A Rhode Island Safety Alert

Manufacturer: [Sartori](#)

Posted By: [Rhode Island Building Commission](#)

Good Day CARES Subscribers: Following are deficiencies in the Sartori Twister/1001 Nights Manual, regarding ONLY the 14 vehicle bolts and nuts:

Vehicle Bolts + Nuts

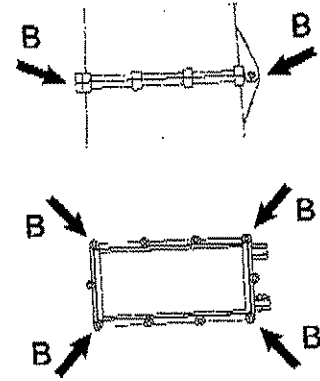
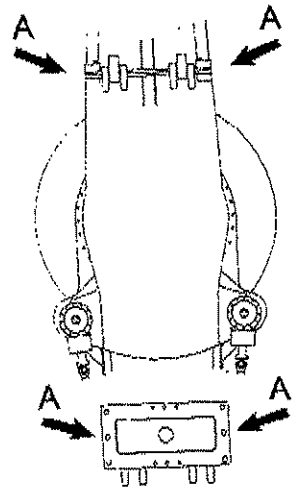
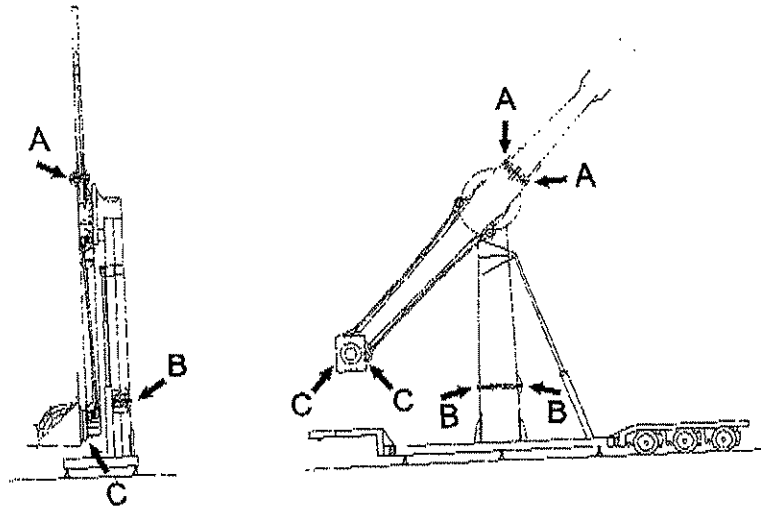
Nuts are not accessible (to inspect them, the vehicle must be disassembled)
